AGC/MoDOT Annual COOP Meeting

December 5, 2018

Safety/Traffic Division & Specialty
Contractor/Suppliers
Breakout Session

Discussion Topics / Submitted Questions

Figure: 616.6.87.1 Temporary Rumble Strip Placement in Flagging Operations

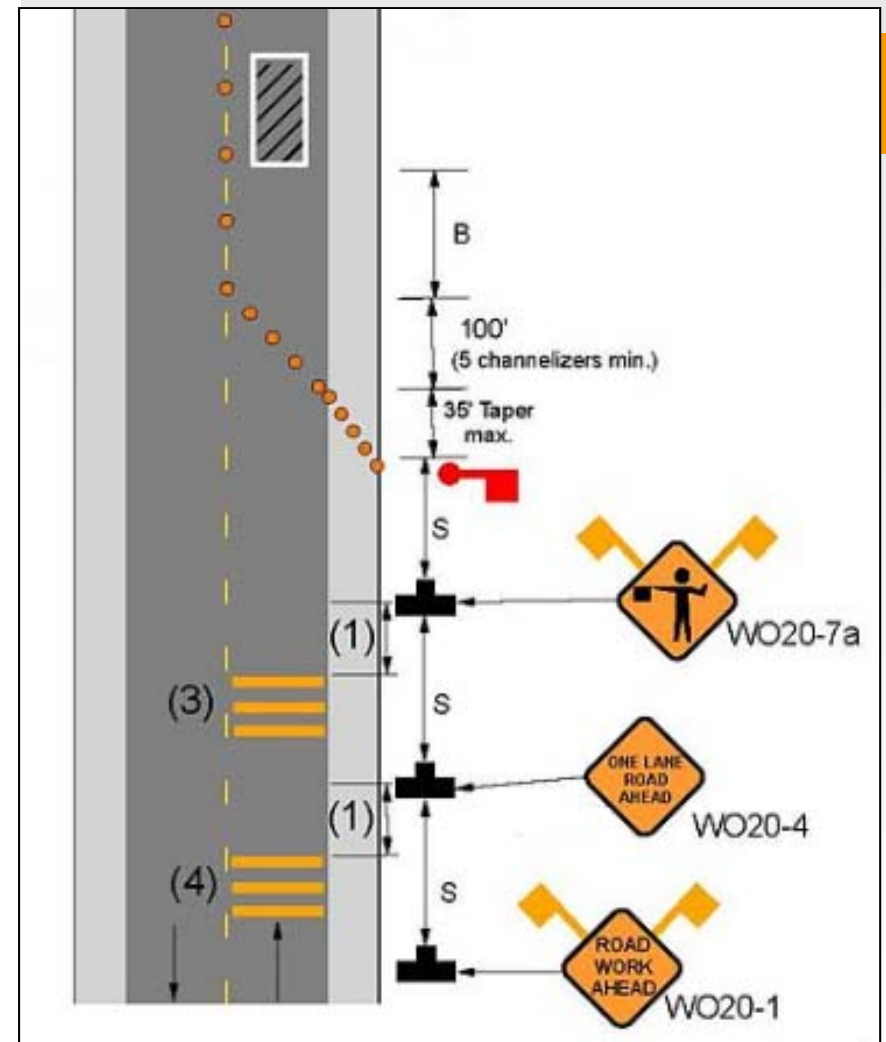
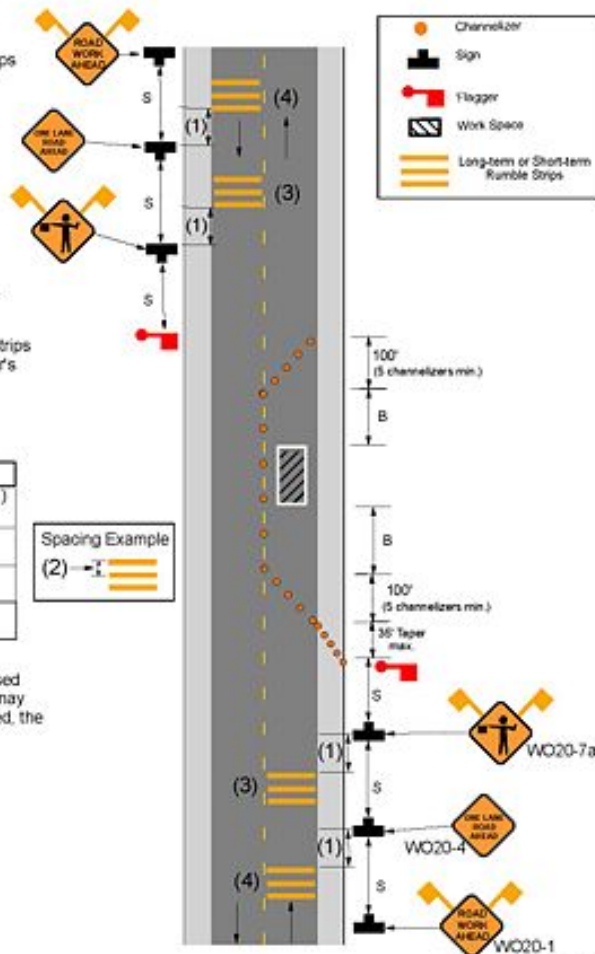
- We have completed a pilot study for the use of temporary rumble strips on MoDOT Maintenance projects
- Currently piloting on contract/construction projects
 - To determine the types of projects temporary rumble strips are applicable to and
 - Type of temporary rumble (short-term or long-term) for type of project
- Current specifications are in Job Special Provisions
- Plan sheet guidance in EPG 616.6

Biggest complaint from workers: short-term rumbles are too heavy

Biggest complaint from contractors: cost of short-term rumbles is really high for orange

Figures in the Engineering Policy Guide – same location for both short and long-term rumble strips; different spacing between and number of rumbles.

Standard Drawing 606.00 and 606.50

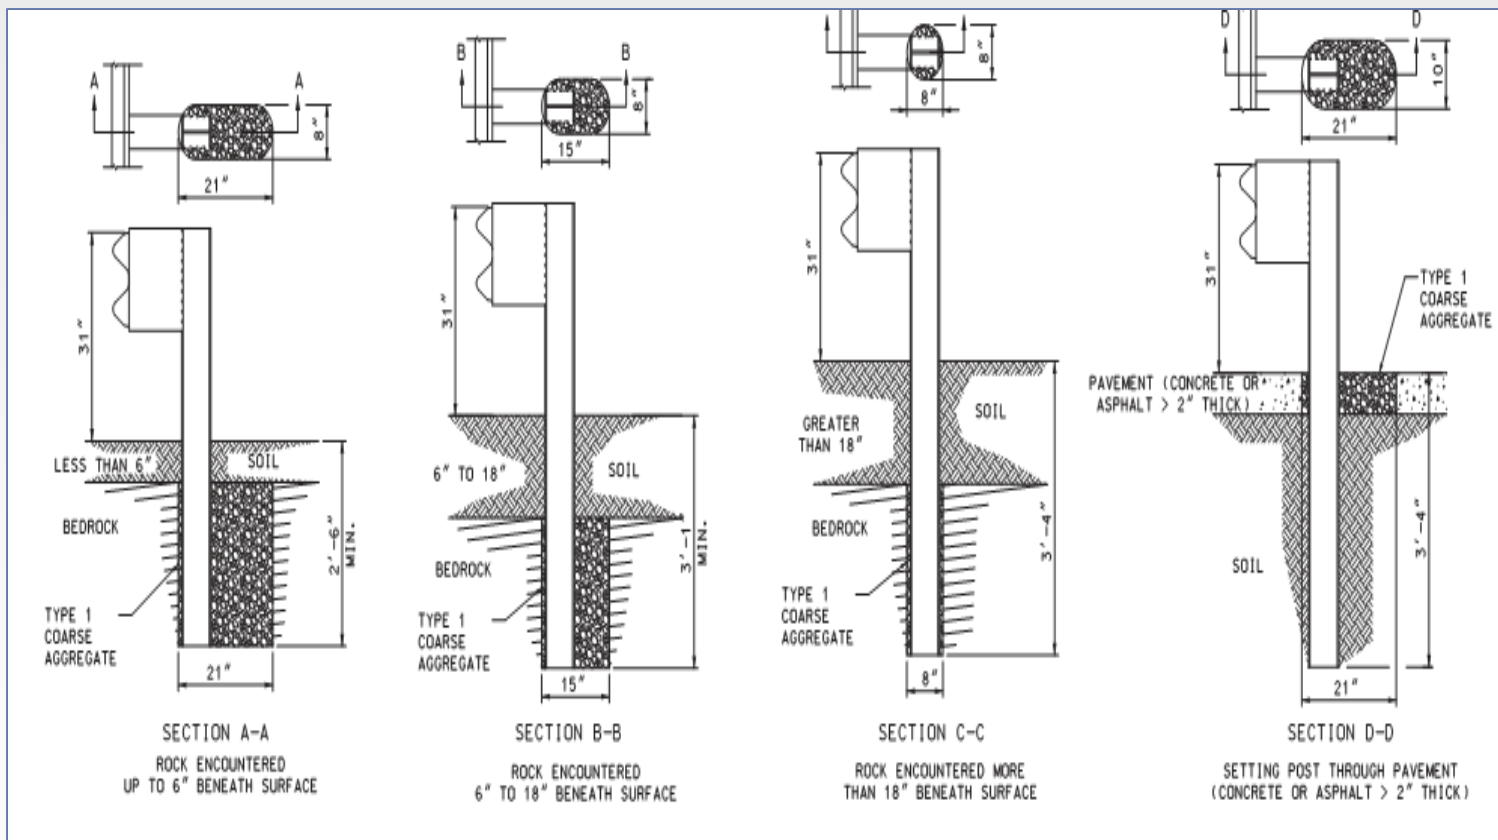
There have been multiple jobs this year that call for rip rap elements for the slide repair fixes in which extremely large rip rap is being placed underneath the guardrail or sometimes underneath the roadway itself. Guardrail cannot be driven through large rocks and can't be drilled either.

The Std. drawings 606.00 and 606.50 have scenarios for installation in differing materials, but rip rap is not included in those drawings. In cases where rip rap is used it is best to work with rip rap installers to start placing posts prior to rip rap; just getting them started not completely driven in.
